Notice of Intent to Conduct Scoping Process and Prepare Environmental Impact Statement NextEra Energy Point Beach, LLC; Point Beach Nuclear Plant, Unit Nos. 1 and 2

SCOPING COMMENTS REGARDING THE PROPOSED LICENSE EXTENSION  
FOR THE POINT BEACH NUCLEAR POWER PLANT

Re: Docket ID: NRC-2020-0277 Point Beach Nuclear Plant, Units 1 & 2  
MARCH 3, 2021  
submitted by

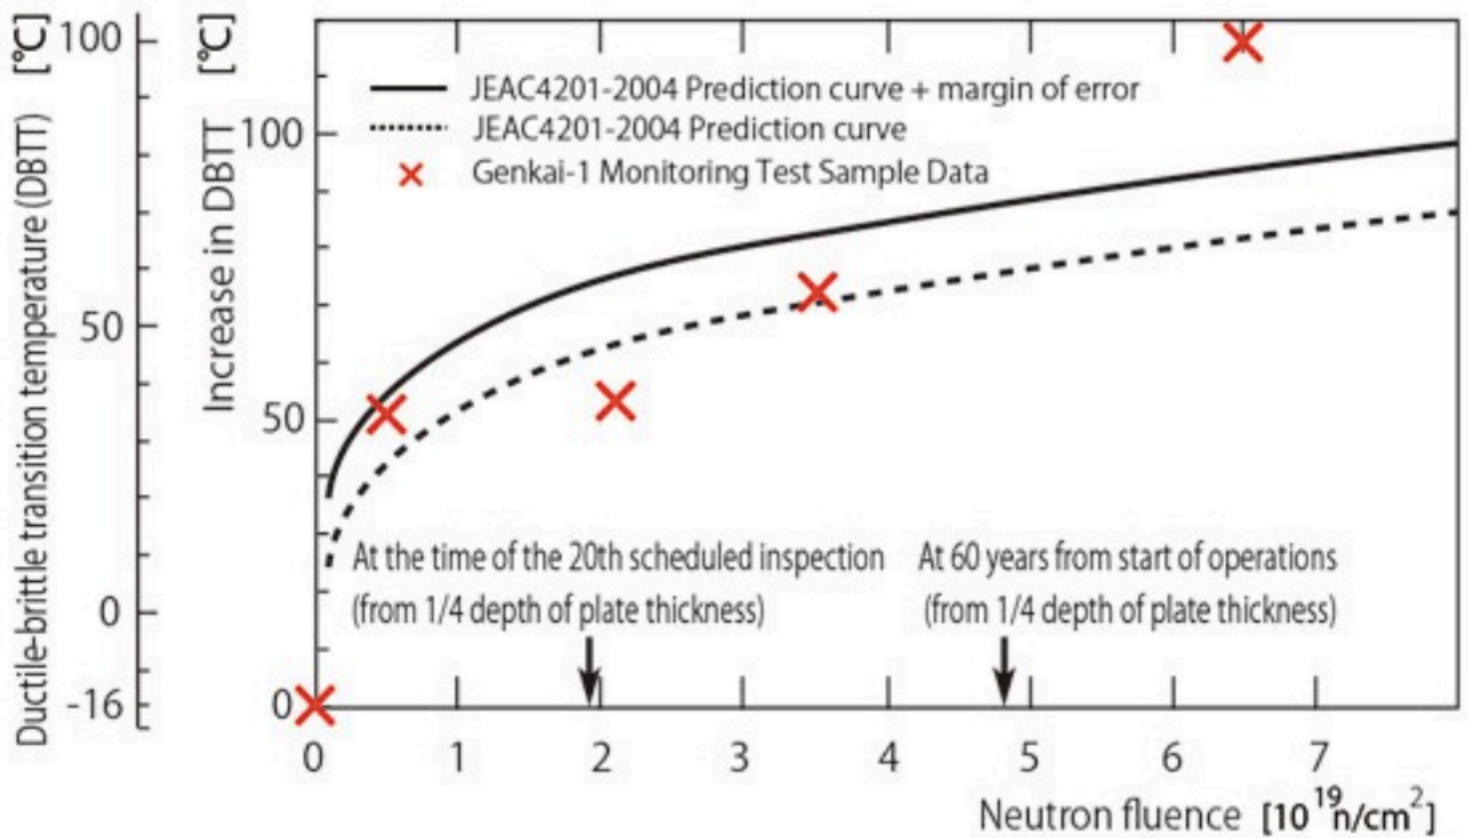
The example of Genkai 1 is definitely a cautionary tale. Computer models of embrittlement made a prediction that did not square with the reality of the physical test. In figure 1, the physical tests are shown with red Xs, and the computer model is the solid line (that allows for the margin of error). After

almost 40 years of operation Genkai 1 was above the 70-year level of the curve. Embrittlement did not conform to the algorithms on which predictions were based.
